2010-012 City of Chattanooga
January 11, 2010

RESOLUTION

CHATTANOOGA
CASE NO: 2010-0012
PC MEETING DATE: 1/11/2010
RESIDENTIAL PUD

P.U.D.:	Mackey Glen Planned Unit Development Lots 1-77
CASE NO.:	2010-012
DENSITY:	3.8 units per acre
DEVELOPER:	D and M Properties, LLP
ENGINEER:	Larry Joe Farrow
DATE OF SUBMITTAL:	December 10, 2009
JURISDICTION:	City of Chattanooga
STATUS:	Preliminary Planned Unit Development Plan

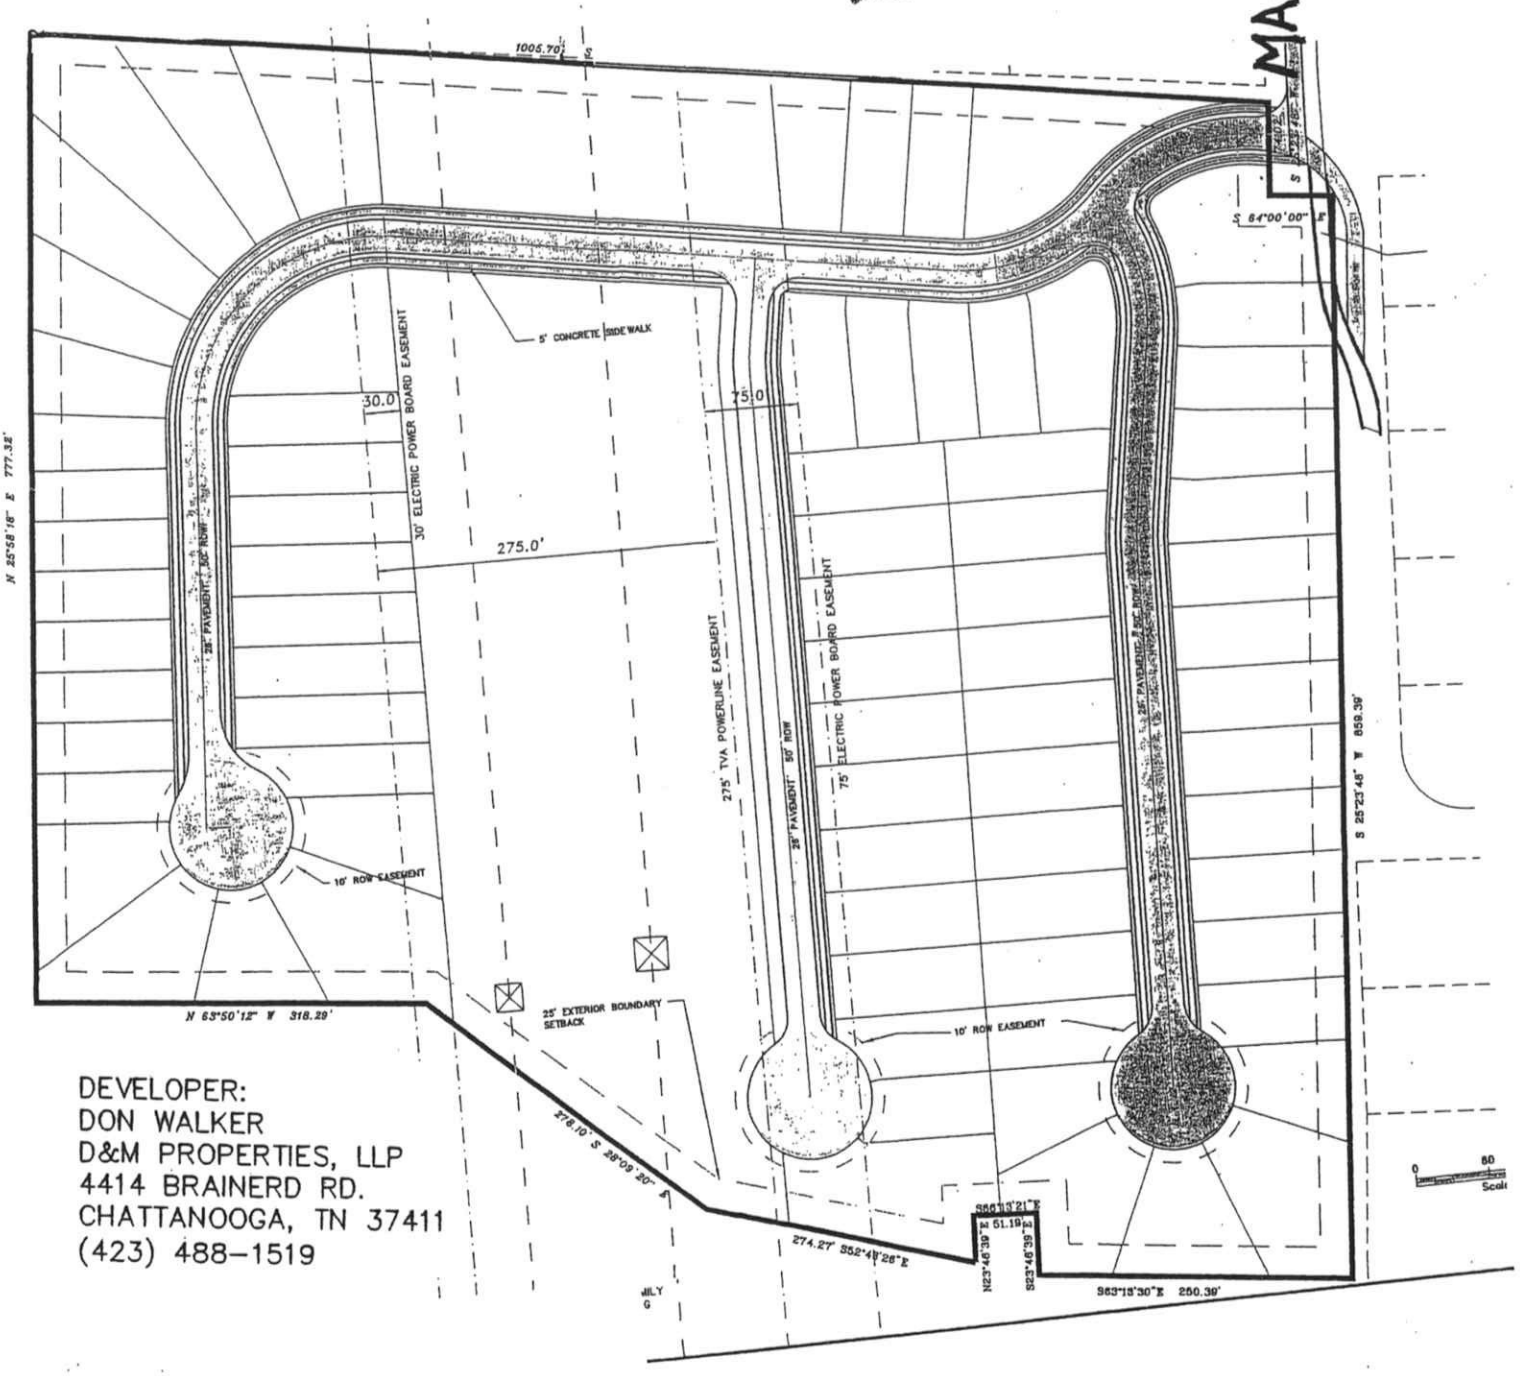
1. Add the following note: "Per F.E.M.A. F.I.R.M. Nos. 470072-0368F and 0369F the 100 year flood elevation is 687'".

2. Show the 100 year flood boundary per F.E.M.A. F.I.R.M. maps and label it as such. Indicate areas above and below.

3. Number all the lots.

4. Section 38-399 of the Chattanooga Zoning Ordinance requires open space in a P.U.D. If lots are to be sold, this open space must be on separate lots. Consequently, label the areas in power easements which are not part of the residential lots as Community Lots 78 and 79. There need to be two lots because the area is separated by a road.

5. Add the following note: "Because the area of Community Lots 78 and 79 is in easements, no building of any kind is permitted on Community Lots 78 and 79. Community Lots 78 and 79 are to be used for utility, open space, drainage detention, recreation and community uses only".

6. Any drainage detention in TVA Powerline Easement will require permission from TVA by letter.

7. Add the following note: "Only detached, single family houses and accessory uses are permitted on Lots 1-77".

9. Show the Tax Map Number as 159P-A-003.023.

10. Since some roads are proposed in the 100 year flood area, the developer should be aware that Section 311.3 of the Chattanooga Subdivision Regulations requires that all roads in this P.U.D. must be at an elevation which is not lower than the 100 year flood elevation of 687'.

11. Since approximately 32 of the proposed lots have building sites which are in the 100 year flood area, the developer should be aware of Section 38-365 of the Chattanooga Zoning Ordinance which reads as follows: "New construction of substantial improvement of any residential building shall have the lowest floor, including basement, elevated to two (2) feet above base flood elevation if constructed of wood or one (1) foot above base flood elevation if constructed of concrete or other material not subject to damage by flood waters, and the minimum building site must be at or above the base flood elevation".

12. Show the owner's name and deed reference for adjoining unsubdivided property and plat book information for adjoining subdivided property.

13. Since there are more than 30 lots in this development, Section 302.3.4.1.1 of the Chattanooga Subdivision Regulations and the Chattanooga Fire Code require that the pavement of the entrance from Mackey Avenue to the first intersection must be a minimum 30' from curb to curb. Accordingly, show 30' of paving in this area.

14. There will need to be a note that the only minimum building setbacks required are 25' from the outer P.U.D. boundary as shown and the minimum 10' between free-standing buildings. If the EPB wants easements along the roads, the setback note will need to reflect these also.

1. Extend the sidewalks around the east and west cul-de-sacs. Extend the sidewalk of the central cul-de-sac to the driveway for the southern most lot. Show these additional sidewalk locations on the P.U.D. plan.

2. Because the proposed road under the TVA Easement will have to be raised to be at or above the 100 year flood elevation, submit a letter from TVA approving the new road elevation under the TVA Easement.

3. Because a road is proposed in the 75' EPB Easement, show the location of existing power poles in this 75' EPB Easement. The proposed curb of the central road must be at least 4' the existing power poles.

4. Show a smooth rounded curb line for the new curb on the east side of Mackey Avenue at the PUD entrance and its adjoining to the existing pavement south of the entrance.

5. Label the power line towers as such.

1. Submit a concrete pavement and curb design crossection.

2. Submit a profile and design for the Mackey Avenue extension. Submit a typical section every 100' for the Mackey Avenue extension.

3. Install standard handicapped sidewalk access facilities with yellow truncated domes where sidewalks are at road intersections.

4. The entire paved surface of roads must be elevated to or above the 100 year flood elevation.

1. Submit information for the capacity of the pump station which will be used for the sewage from this development.

2. For the sewage from this development, submit calculations for average flow, daily flow and peak flow.

3. Sewer plans and profiles are needed for further review.
